**Review of DOE Planned Change Request for
Shielded Containers for Remote-Handled Transuranic Waste**

**Contract Number EP-D-10-042
Work Assignment No. 1-02
Revision 4**

December 29, 2010

Figure 5-1: Mean DBRs from SCPA Scenarios 2 and 3 and PABC-2004, Replicate 1
(Dunagan et al. 2007)

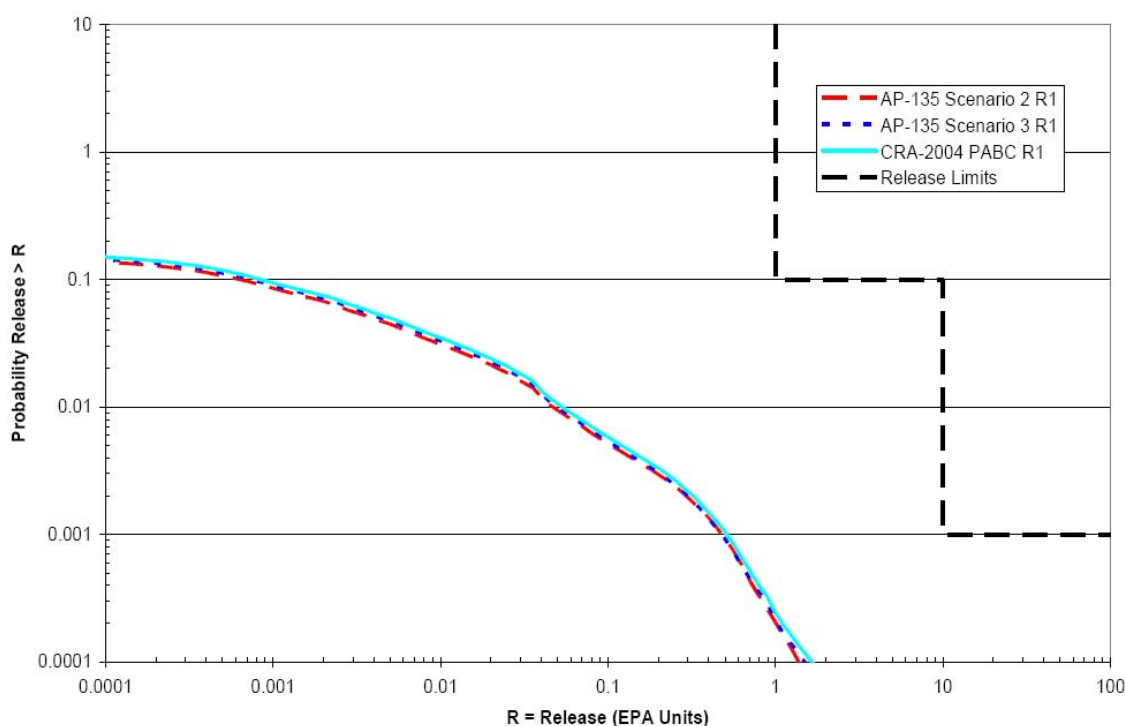
DOE indicates that the mean DBR CCDFs have no significant differences between SCPA scenarios and the PABC-2004. Based upon Figure 5-1 (from Dunagan et al. 2007), this assertion also appears to be supported. However, as shown in that figure, the mean DBRs for SCPA Scenario 2 are consistently the smallest, and the mean DBRs for the PABC-2004 are consistently the largest, but the differences are minor.

DOE also indicates that even though the PABC-2004 had the largest mean DBRs at all probabilities, the difference between the DBRs for the PABC-2004 and the SCPA scenarios was still extremely small and not large enough to discernibly impact mean total releases.

DOE satisfactorily explains the differences between the various scenarios, and their assertion that the differences are small is supported by the results presented in Figure 5-1.

Figure 5-2: Mean Total Releases from SCPA Scenario 2 and Scenario 4, Replicate 1
(Dunagan et al. 2007)

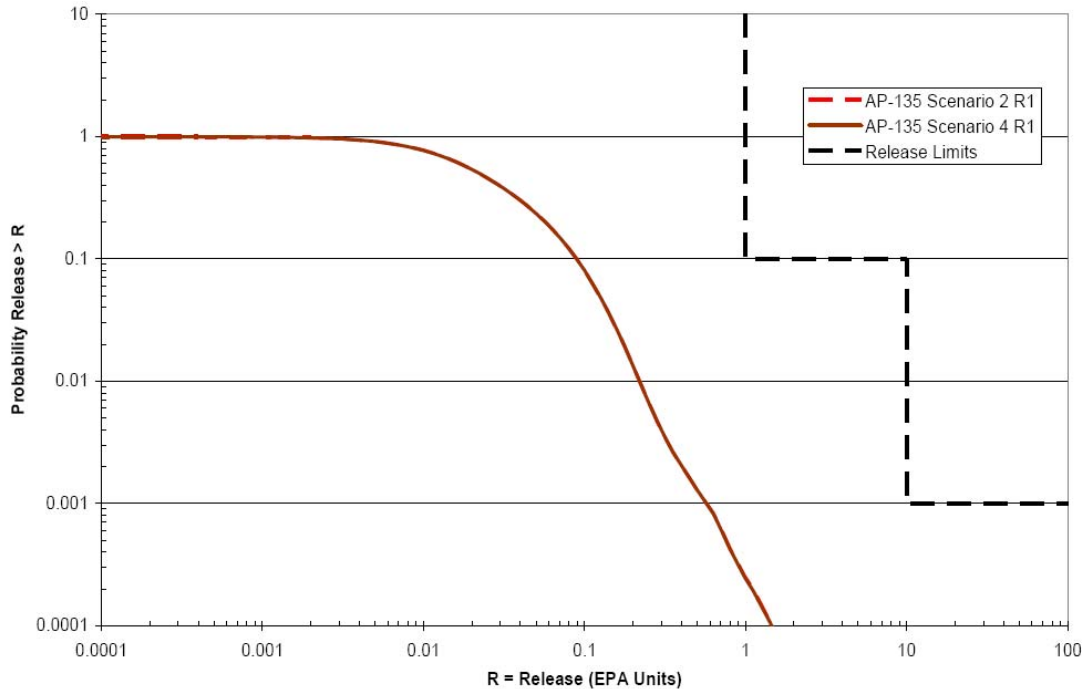
The total normalized releases for SCPA Scenarios 2 and 4, Replicate 1, are compared in Figure 5-2. DOE concludes that modeling the use of shielded containers with explicit representation of all 77 individual RH waste streams caused no differences of practical significance on the mean releases.

DOE’s conclusion is supported by the results presented in Figure 5-2, in which the mean total releases for each of the scenarios are virtually indistinguishable from one another.

Figure 7-1: Shielded Container

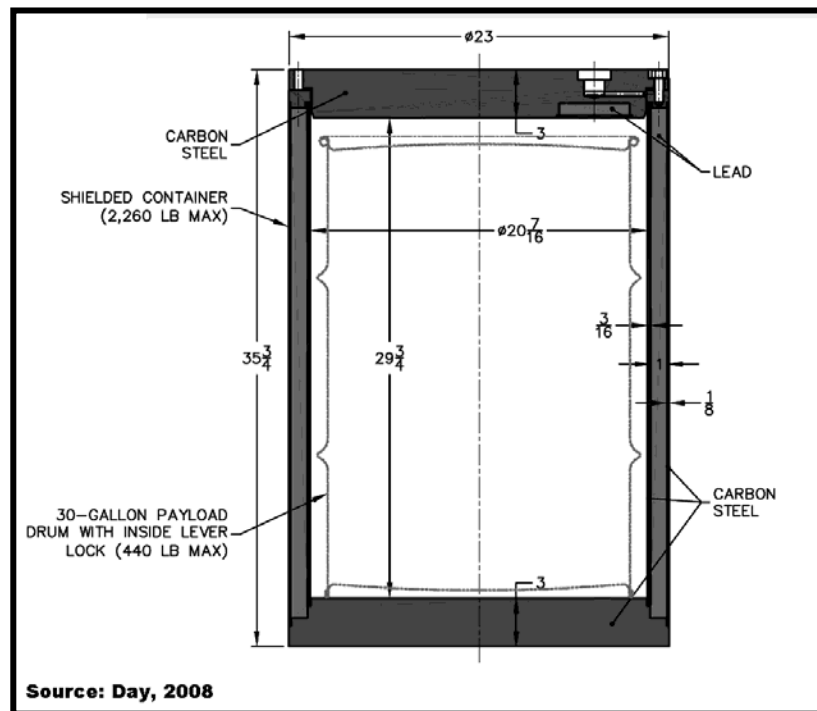
Figure 7-1 shows a schematic of the RH TRU waste shielded container (Day 2008). It has been designed to hold a single 30-gallon drum having outside dimensions consistent with those of a 55-gallon drum. For comparison purposes, the dimensions of DOT-17C 30-gallon and 55-gallon drums are given in Table 7-1.
